B. PUBLIC AGENDA ITEMS

TO: Planning and Zoning Commission
FROM: Evann Martin, Assistant Planner
DATE: January 4, 2022
RE: Destination Market Plat 7 – Final Plat

RE: Jordison Construction Site Plan

The Development Services Department is in receipt of a proposed Site Plan for Jordison Construction. Based on the review of the provided submittal materials, staff have the following comments:

SITE SURVEY/DEMO PLAN

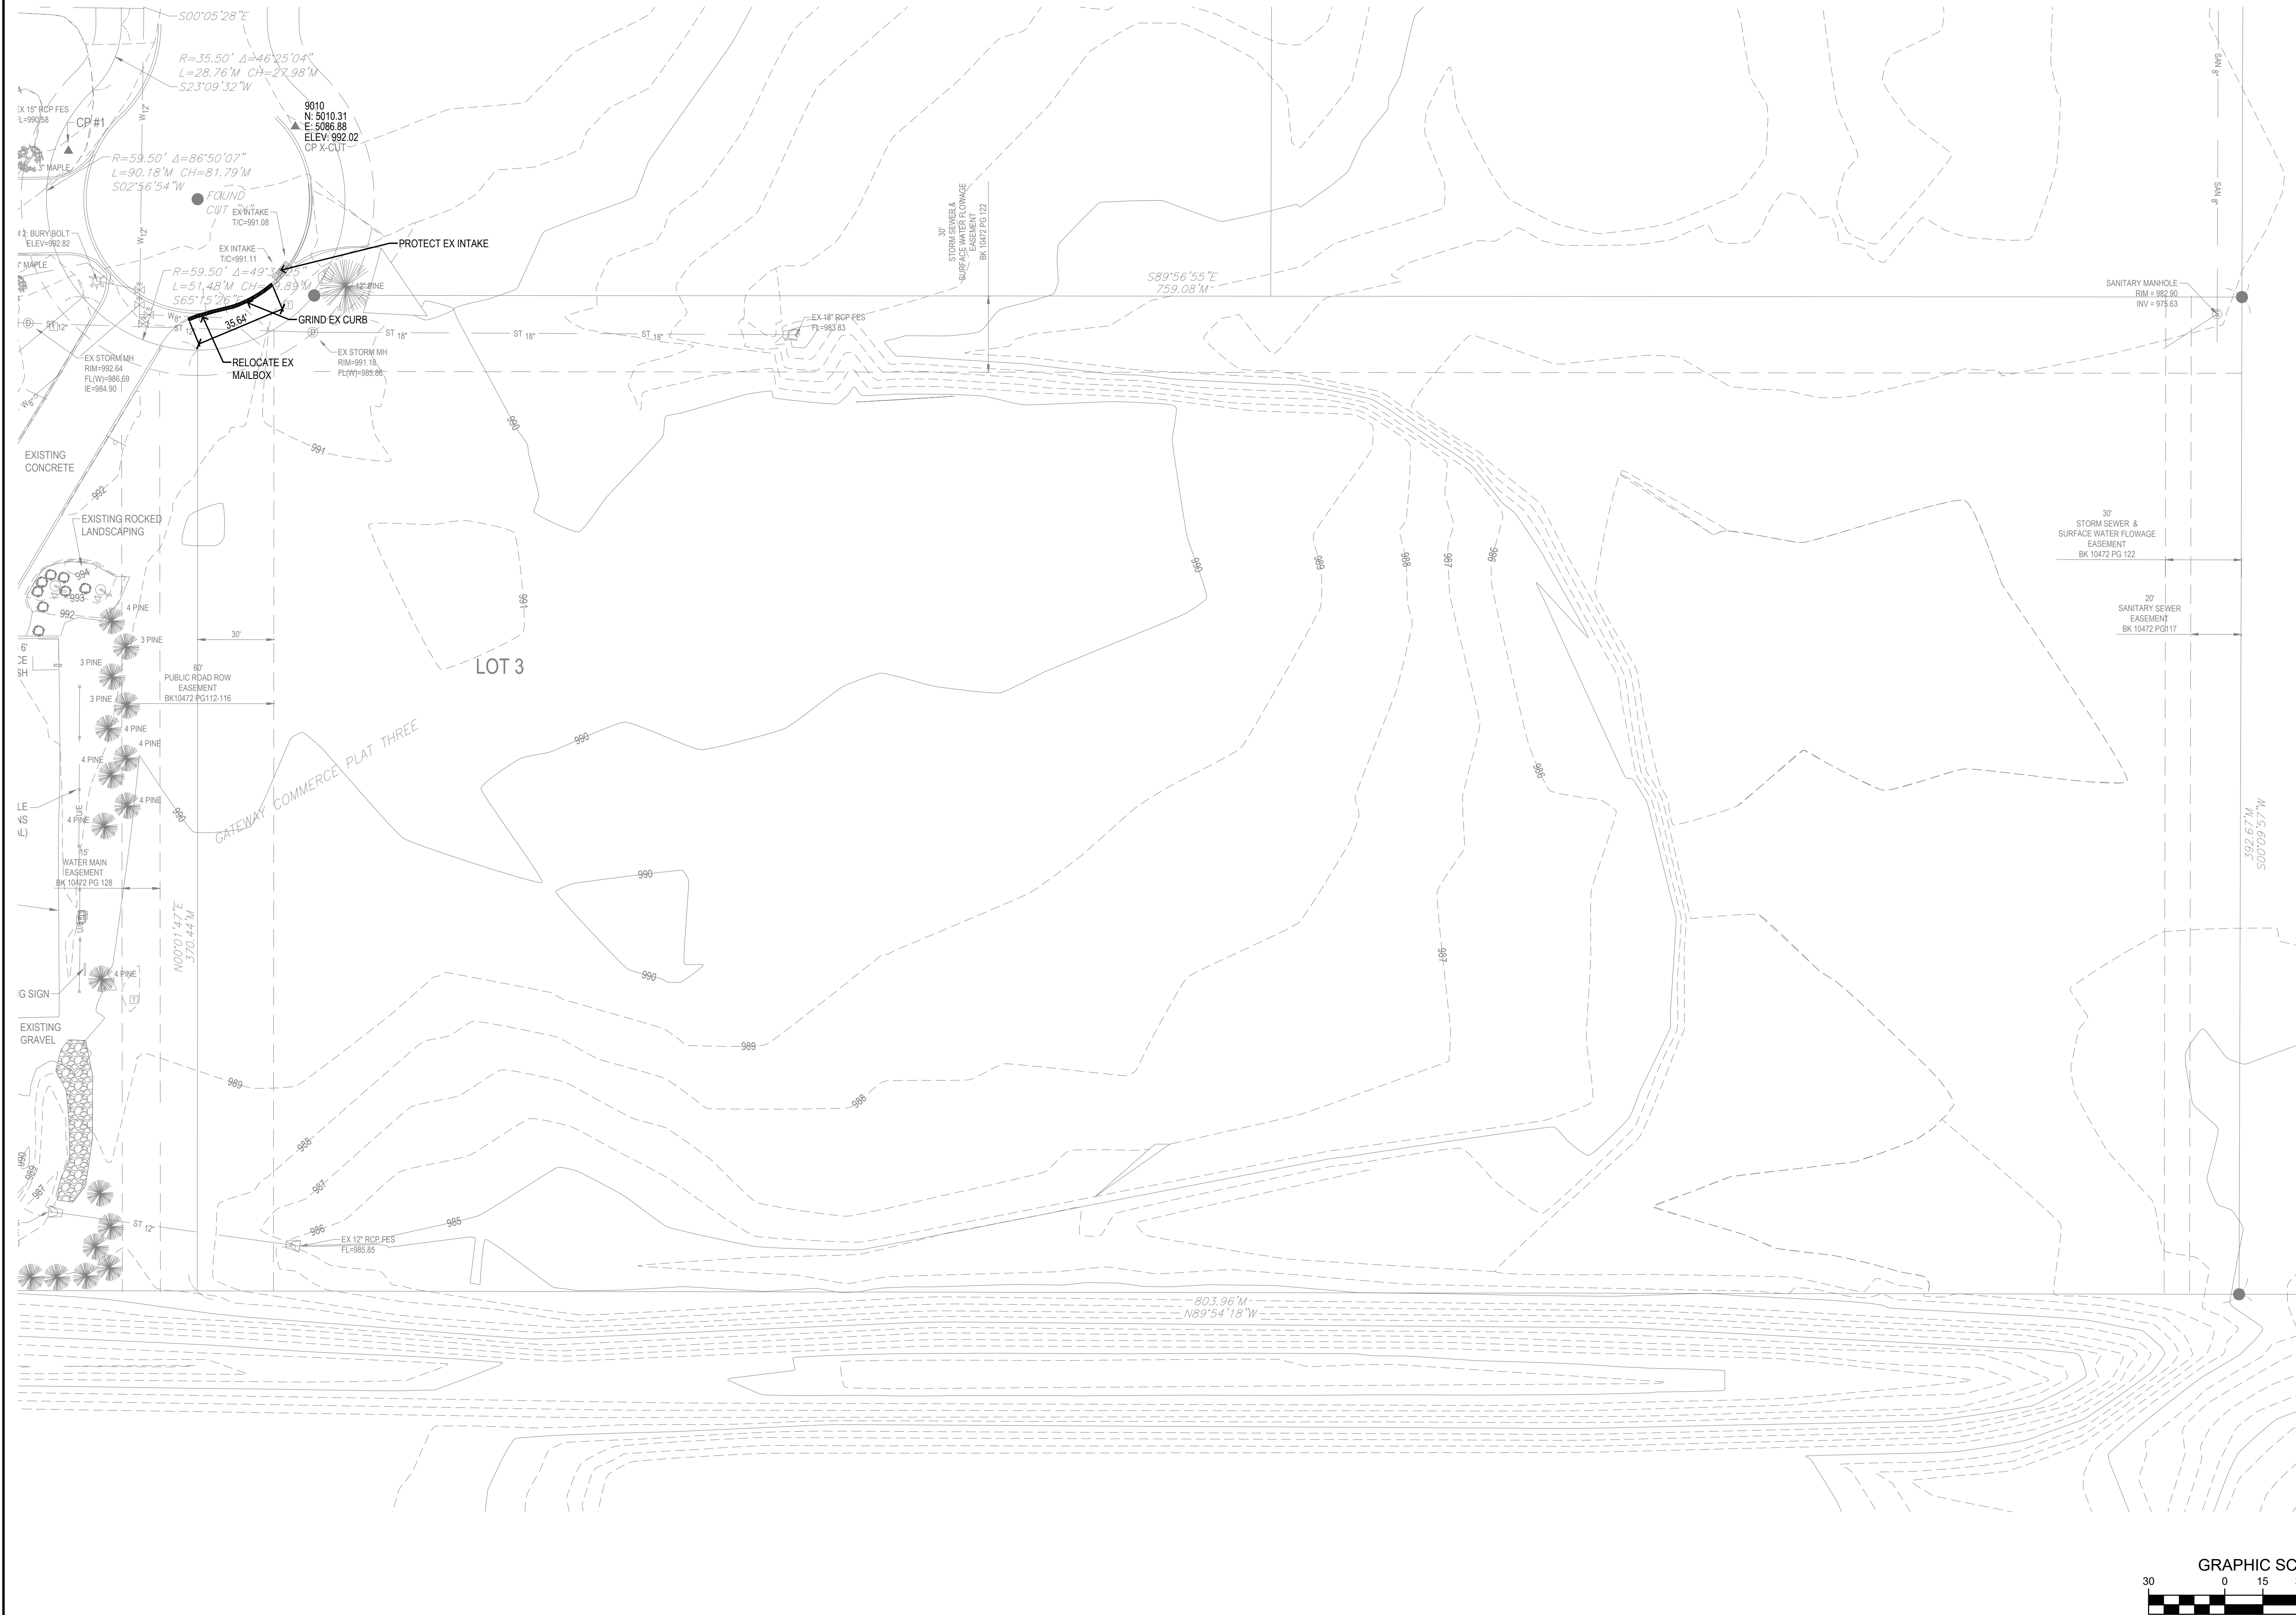
C1.1:

1. ~~Label curb length to be removed.~~
2. Show site removals (granular, fence, etc.). **Please provide.**
3. What is MB? **On Sheet 2.1, show new mail box location outside of the driveway pavement.**
4. ~~What is T?~~
5. ~~Add book and page for all existing easements.~~

LAYOUT PLAN

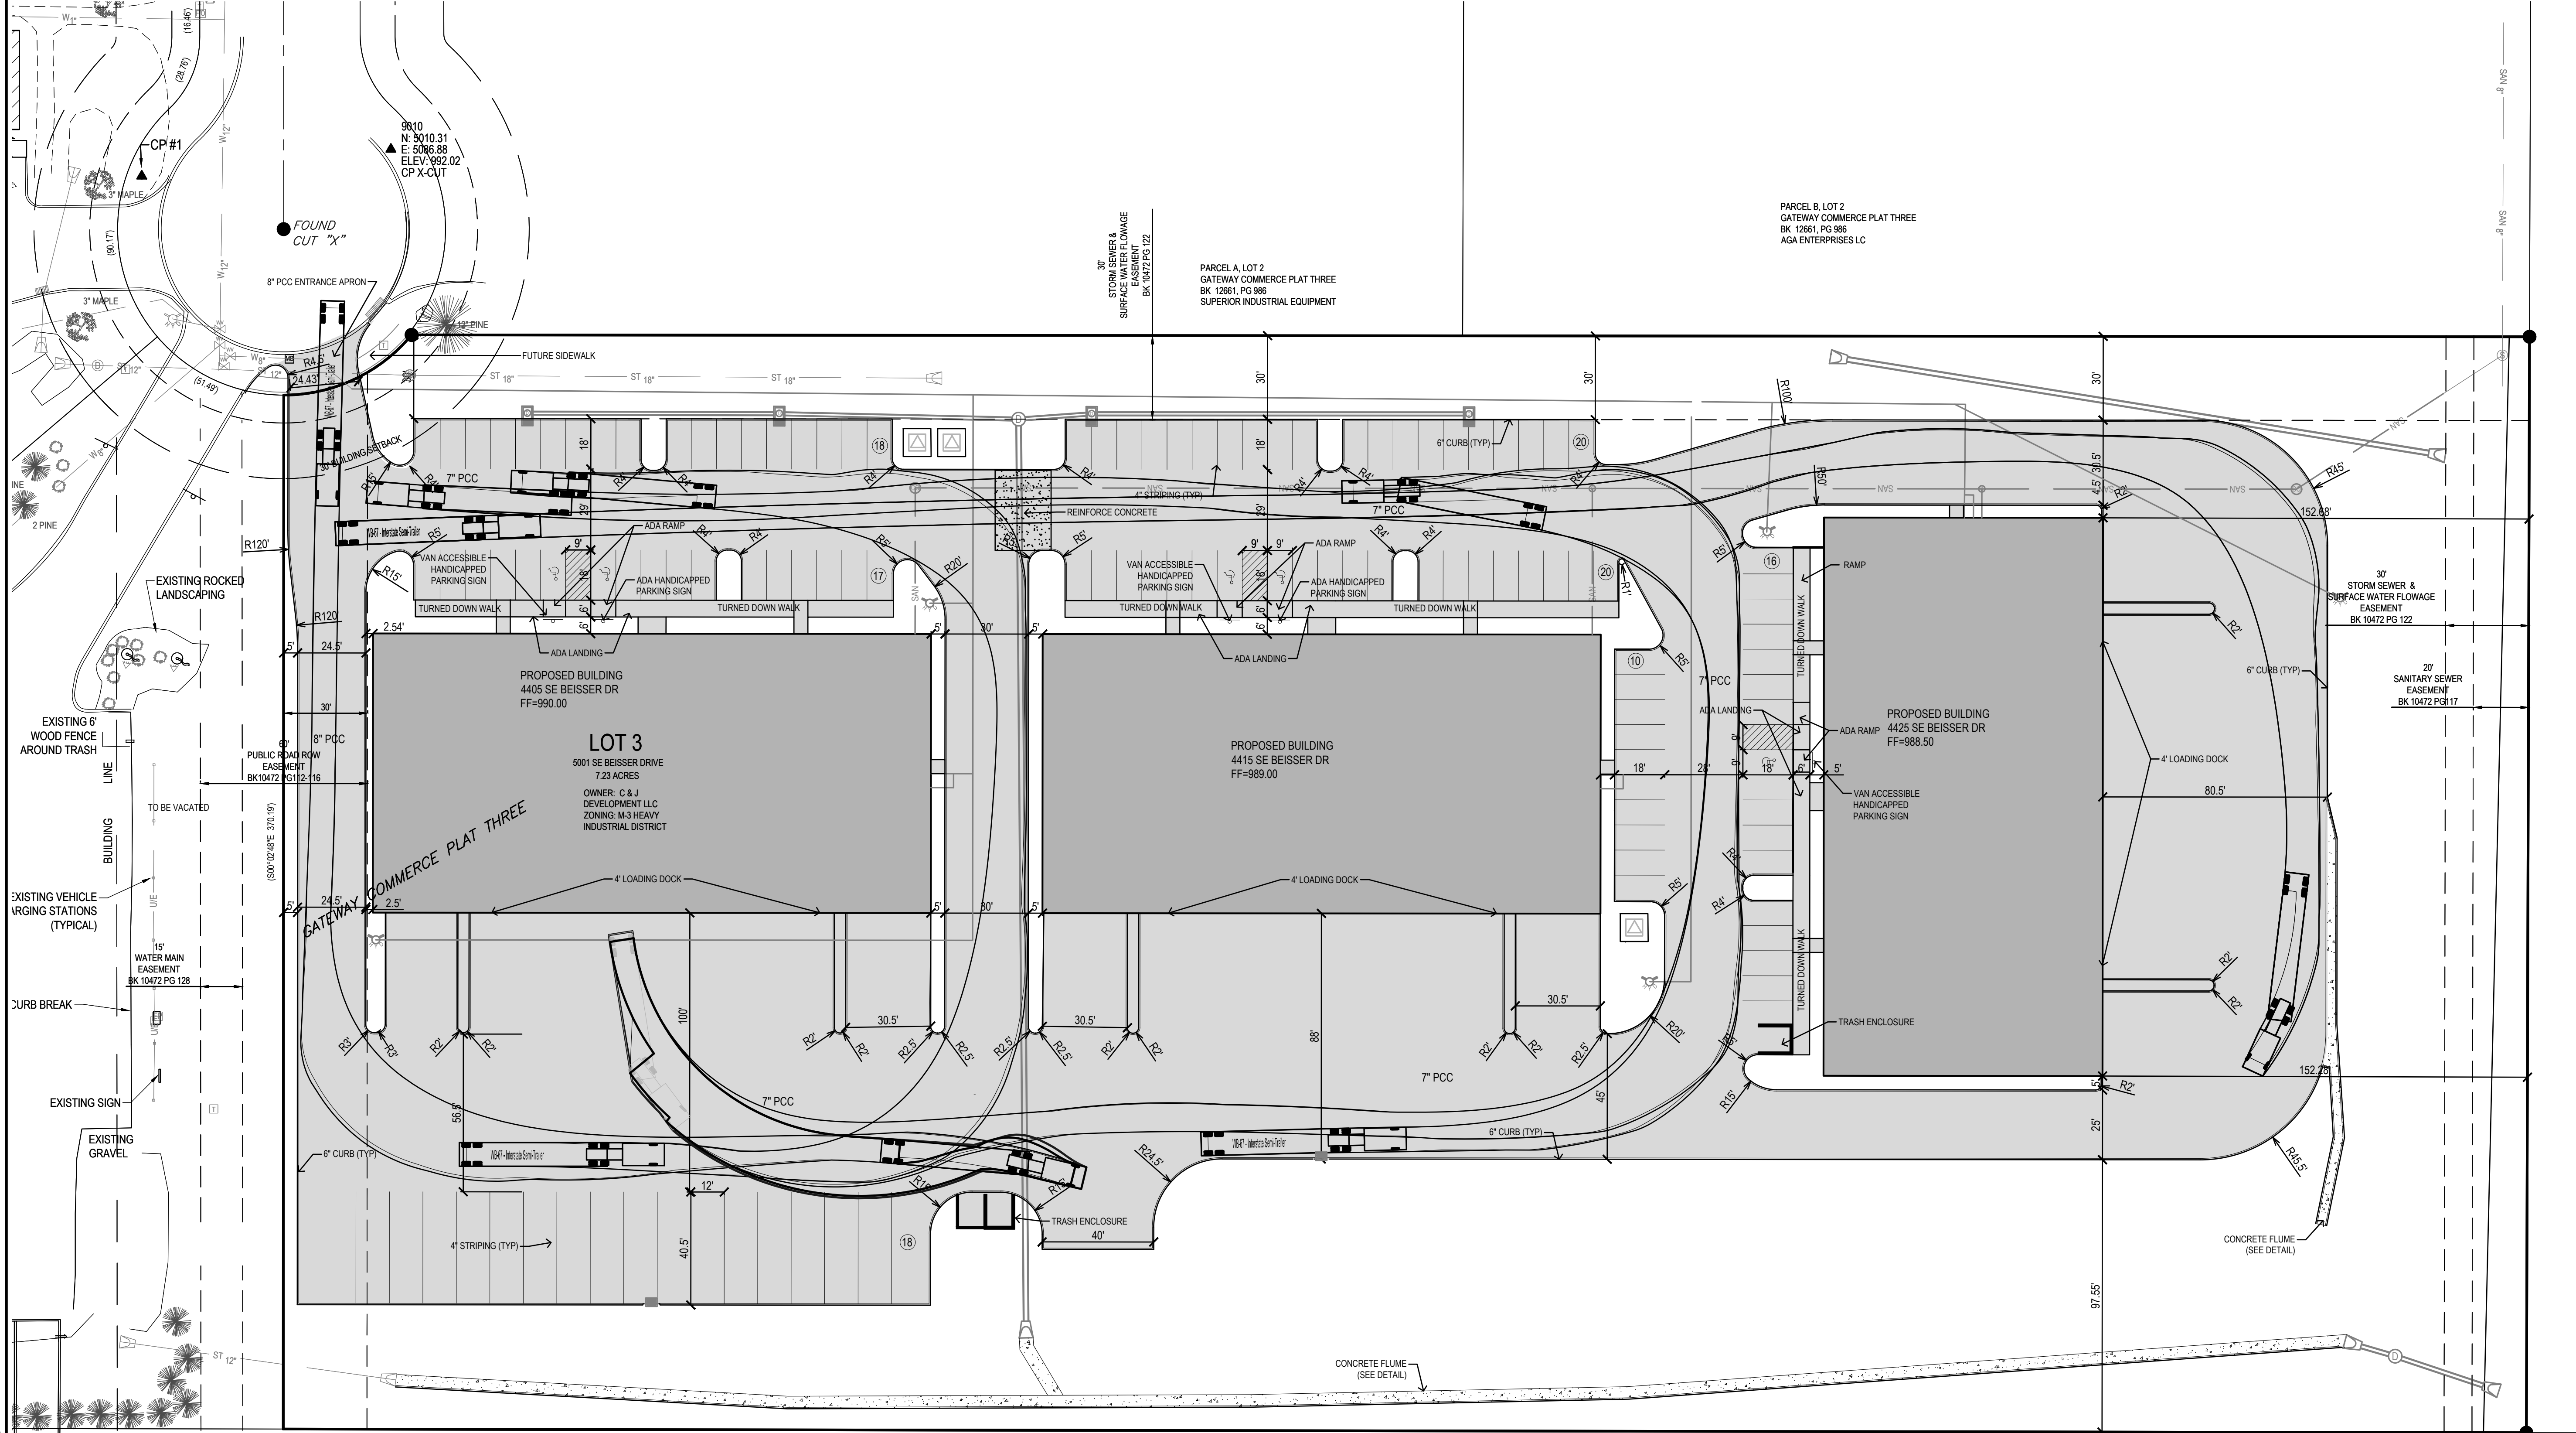
1. ~~Label future sidewalk along SE Beisser. Not shown.~~
2. The ROW easement will need to be vacated which will require a public hearing. Please provide an exhibit showing the area to be vacated. **Please provide a legal description of the area to be vacated.**
3. ~~Paving needs to be at least 5' from the west property line. There is no need for a variance for this since there are other options/space available to meet the setback. At the driveway, the pavement can taper from the current proposed location to a 5' setback. It does not need to be 5' along the entire west property line.~~
4. ~~Label the width of the driveway entrance.~~
5. ~~Please revise the radius on the landscape islands in the areas highlighted below to R15' Please revise radius just south of the driveway entrance.~~

8. Are dumpsters proposed onsite? Please show locations and provide a detail. Can the dumpster be moved away from the front of the east building? At a minimum, the parking space just north of the enclosure needs to be widened by 2'.

9. ~~Why is there reinforced concrete proposed?~~
10. Are parking lot lights proposed? Please label the locations on the site plan and provide a photometric plan and lighting cut sheets. Please provide lighting details for the east half of the site.

11. ~~On the building elevation, a door is shown on the east elevation. On the site plan, there is no sidewalk or landing for the proposed exit to a parking lot or a public way. Per section 1028.5 of the 2018 International Building Code, a direct and unobstructed access to a public way is required. Please provide a sidewalk and landing for the door on each building.~~
